**Milton CN Intermodal Logistics Hub Development Project
Review of Environmental Impact Statement (EIS)
and Supporting Documents**

Impacts of Outdoor Lighting

Submitted to:
Region of Halton

March 9, 2017

FIG. 2—Horizon-zenith-horizon scans, on the meridian, of five night skies: a) downtown Toronto, March 20, 1975; b) Palermo, Ontario, September 16, 1974; c) Lynden, Ontario, September 14, 1974; d) Cyprus Lake Provincial Park, September 6, 1975; e) Junipero-Serra Peak, California, from Walker (1973).

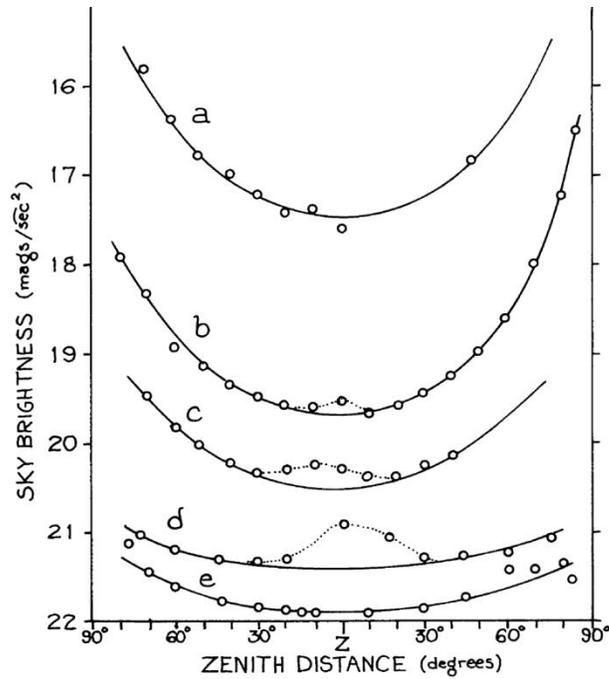
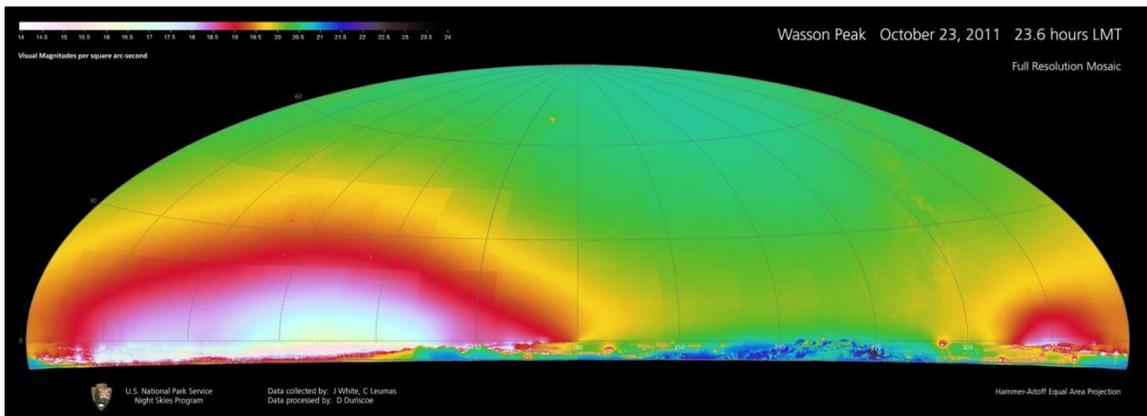
These measures were made along a great circle crossing the sky from horizon to horizon, passing through the zenith. Particularly in regions like that under consideration here (cf. profile b), the contribution of artificial lighting to the sky glow is dramatically greater toward the horizon. All-sky panoramic measures made with modern instrumentation show the effect even more dramatically, as shown by this map made by the US National Park Service near Tucson Arizona:

The impacts of the Project lighting can be expected to be much more significant away from the zenith in the direction toward the Project. The SQM-L meter is not suitable for measuring sky glow away from the zenith, as its large field of view means that it will begin to include portions

of the landscape in the measurement which will bias the measures low. Any directly visible (glare) sources will also contaminate the measures.

| Topic | Reference to CN EIS, EIS Guidelines and Information Responses | Requested Information | Rationale |
|--|---|--|---|
| <p>Sky Glow Levels</p> <p>EIS Guidelines, s. 6.1.1, 6.2.1</p> <p>Halton Brief, Table D.7, Night-Time Light on Residential Receptors</p> | <p>EIS Appendix E.8, Lighting Report, Section 4.2.1</p> | <p>RL.3 Assessment of Baseline Sky Glow over Entire Sky</p> <p>Please execute measures documenting sky brightness of the whole sky, from zenith to horizon.</p> | <p>The Unihedron Sky Quality Meter with lens (“SQM-L”) is not adequate for total sky assessment. An evaluation of the entire night sky is needed to determine current sky glow levels, not just measurements in a limited portion of the sky.</p> |
